# Seattle Light Rail Review Panel

## APPROVED MEETING MINUTES

# Roosevelt Station

Design Development

**Figure 2.** The LRRP members identified these narrow and difficult to maintain sections of landscaping as an area for refinement as the team moves towards the final design.

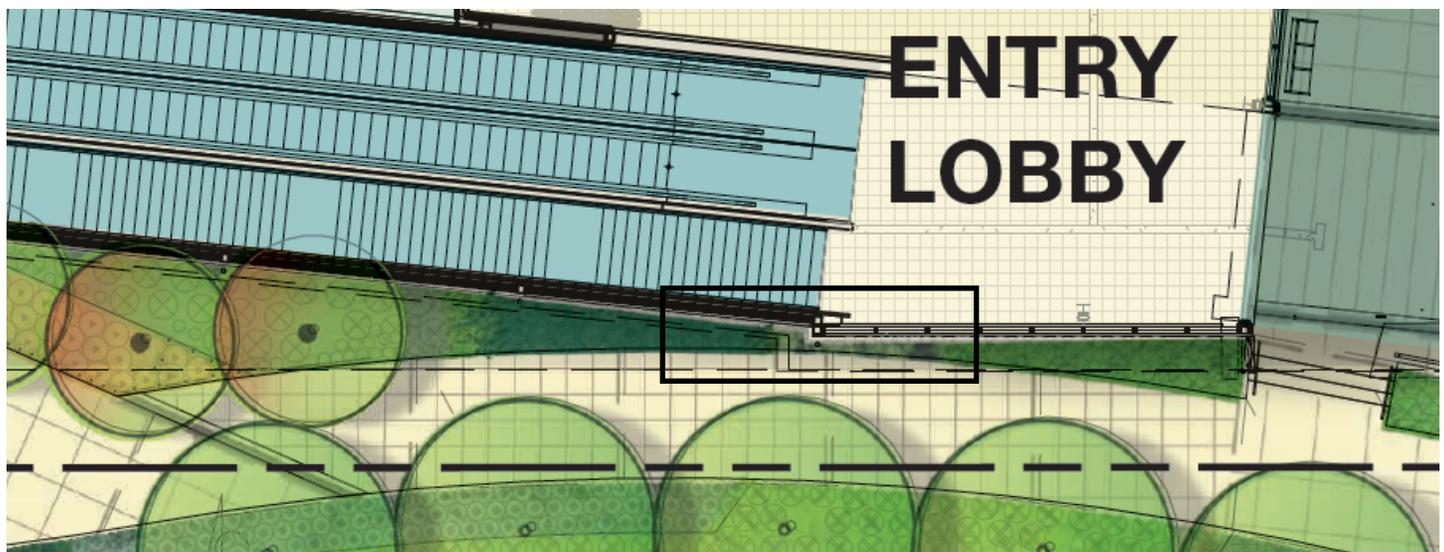
The LRRP members cautioned the team about narrow sections of landscaping where maintenance will be difficult, as shown in Figure 2 below. They noted that the kink in the building just south of the north entry lobby will draw particular attention to the ground plane and landscape in that area. The LRRP also commended the team on creating such a generous landscaped area with street trees along 12th Ave NE but was disappointed that power lines would not be undergrounded in the station area since it would create opportunity for trees.

**Figure 5.** The LRRP was disappointed not to see further updates to the plaza design since the November 20, 2014, review of the station artwork. Some LRRP members had reservations about whether integral color for the concrete bench would match the metal sculpture.

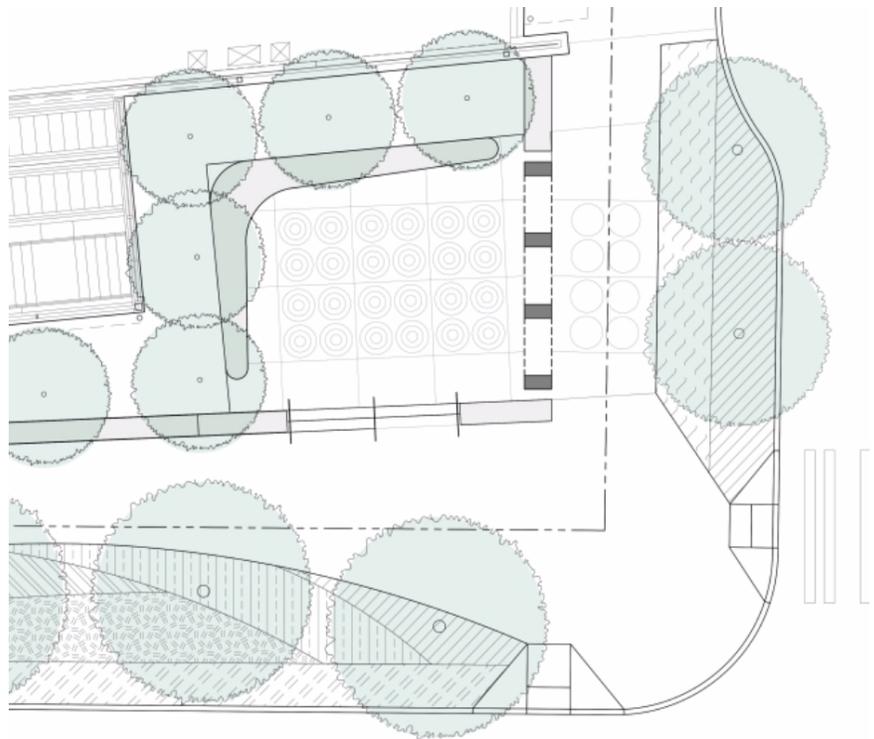
the design of the plaza at 12th Ave NE and NE 66th St given the recommendations and three dissenting votes at the LRRP's November 20, 2014, review of the station artwork.

The LRRP also saw evidence of close collaboration in the integration of Luca Buvoli's artwork into the station design. However, the LRRP was disappointed not to see more evolution in the design of the plaza at 12th Ave NE and NE 66th St following the several recommendations the LRRP made at its November 20, 2014, review of the station artwork.

2. Continue to refine the execution of the plaza at the corner of 12th Ave NE and NE 66th St to be a successful and inviting place. Consider a more consistent approach to paving across the entire plaza area, and allow the "room" to extend out beyond the sculpture. Ensure the proposed integral color for the bench matches the metal of the sculpture.
3. The development of Luca Buvoli's artwork at the platform level is encouraging. Continue to study how the artwork can integrate effectively with the glass in the station entry.
4. In the station box, emphasize the big architectural moves of the columns and the beams that separate them, as shown in Figure 3. Use lighting intentionally to express and/or complement these architectural pieces. Avoid competition between the geometry of the columns and beams and the geometry of the mezzanine.
